UNITED STATES PATENT AND TRADEMARK OFFICE

10/762,963

Office Action Summary	Application No. 10/762,963	Applicant(s) TAYLOR ET AL.	
	Examiner JOHN F. RAMIREZ	Art Unit 3737

DETAILED ACTION

Fig. 12

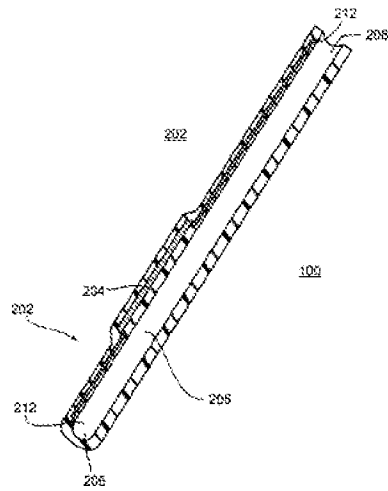
The Porat et al. reference disclose an acoustic monitoring device (204) for verifying the pressure setting of a valve mechanism in an implantable device (see abstract, col. 19, lines 40-65), comprising: a transmitter (214) configured to generate an energy field sufficient to effect movement of the valve mechanism of the implantable device (see figures 6-9); and an acoustic sensor (212) electronically coupled to the transmitter (214) for detecting acoustic signals (see abstract, see Fig. 13, see col. 19, lines 40-65), wherein the transmitter (214, 114) creates electrical power for energizing the sensors (see Fig. 10, col. 15, lines 39-63), further including a housing having a top surface, a bottom surface, and a central opening (205) extending therethrough for containing the transmitter (214), including a tubular coupling member (205) extending through the central opening, wherein the tubular coupling member is configured to contact a patient's skin (208, see col. 19, lines 15-40), wherein the acoustic sensor is selectively disposed within the tubular coupling member as shown in Figure 12, wherein the acoustic sensor is electromagnetically isolated from the transmitter (see figure 13

and col. 19, lines 55-65), further including mechanical isolating pads surrounding the inner surface of the tubular coupling member (see figure 12), wherein the sensor (212) is seated on top of the tubular coupling member (see sensors mounted on the upper surface of tubular area 205), and including a digitizing filter, and a data storage unit for transmitting any detected acoustic signals to a programmer for analysis (see Fig. 10, see col. 19, lines 65 – col. 20, line 26).
